MESA ENGINEERING

Date: August 19, 2008
 To: West Park PUD Neighbors
 From: Bruce Melton, P.E., Oak Hill, Texas
 Re: Implications for Development Buildout, West Park PUD

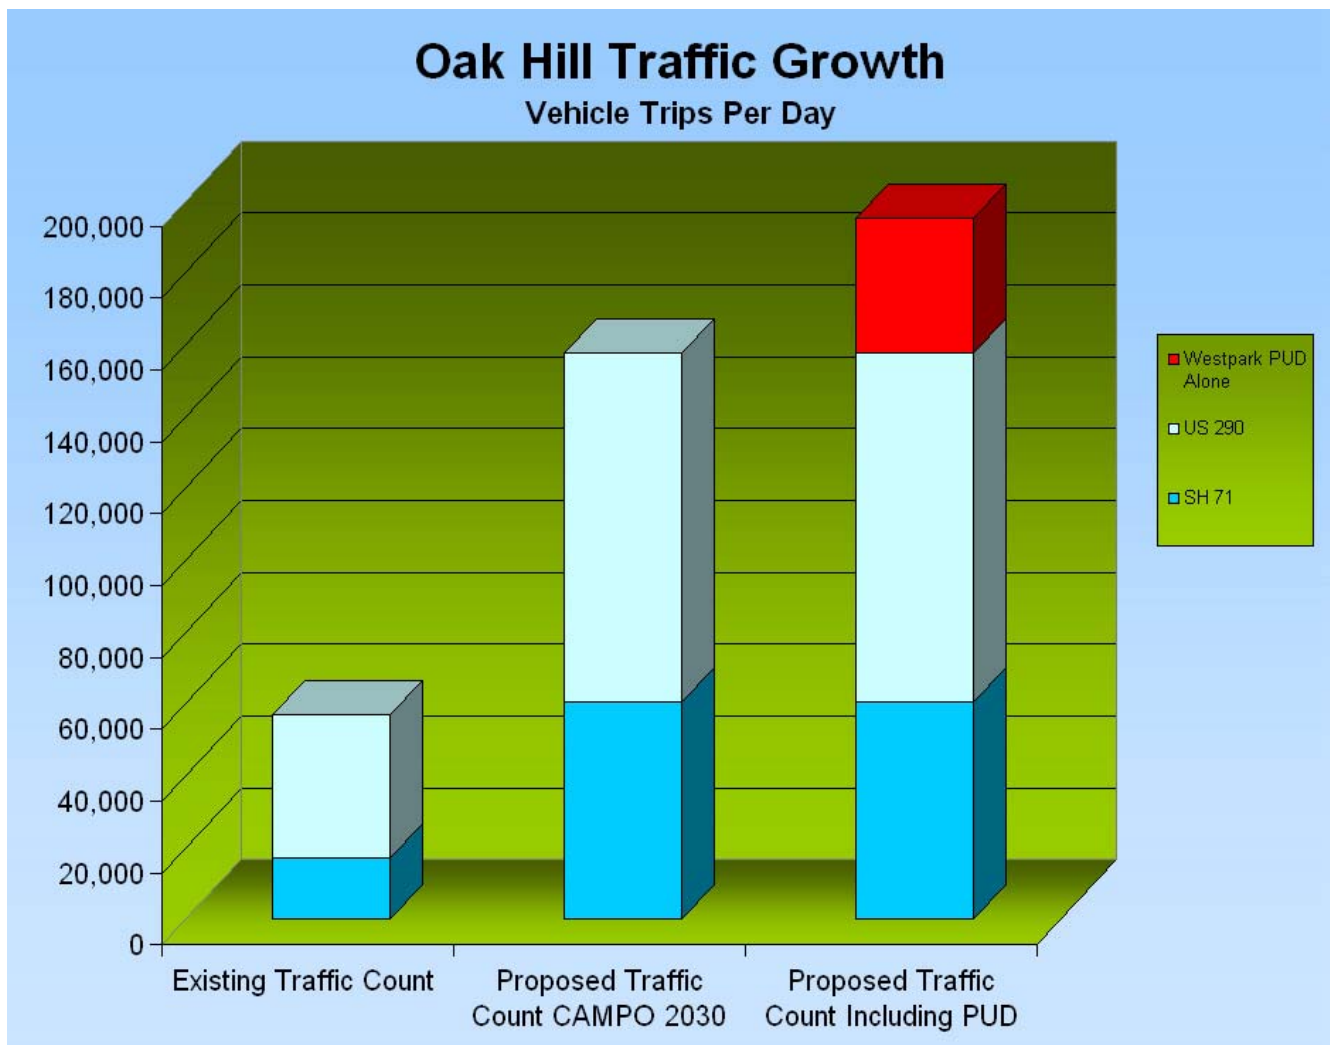
- 4) This “mega development” poses extreme implications for traffic congestion in Oak Hill as shown in the chart below:
